CHAPTER 3  
INSTALLATION REQUIREMENTS

SECTION 301  
GENERAL

301.1 Scope. The provisions of this chapter shall govern the installation of photovoltaic (PV) components including location, materials and structural support. Where the installation of PV systems is not covered by this chapter the installation shall be in compliance with the applicable provisions of the Oregon Building Code as defined in ORS 455.020.

Figure 305.3.3.1.1(1) Installation – Rails perpendicular to framing members

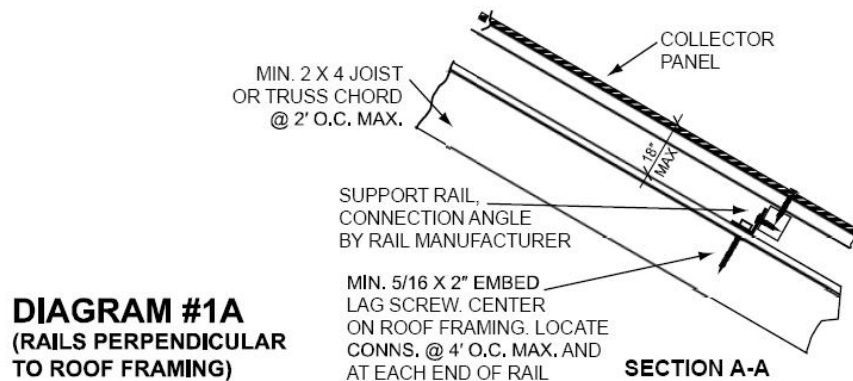
3. Loading: PV modules or racking shall ~~either~~ be directly attached to the roof framing or blocking installed in accordance with Figure 2 ~~or mounted to continuous rails that are attached directly to the roof framing~~. These attachments must be ~~anchored to roof framing at a spacing~~ no greater than 48 inches (1219 mm) on center ~~maximum~~ in any direction where ground snow loads do not exceed 25 psf and no greater than 24 inches on center ~~maximum~~ in any direction where ground snow loads exceed 25 psf. Installation shall comply with Figure 305.4(1) or 305.4(2). The combined weight of the PV modules and racking shall not exceed 4.5 pounds per square foot (~~xxx~~ kPa).
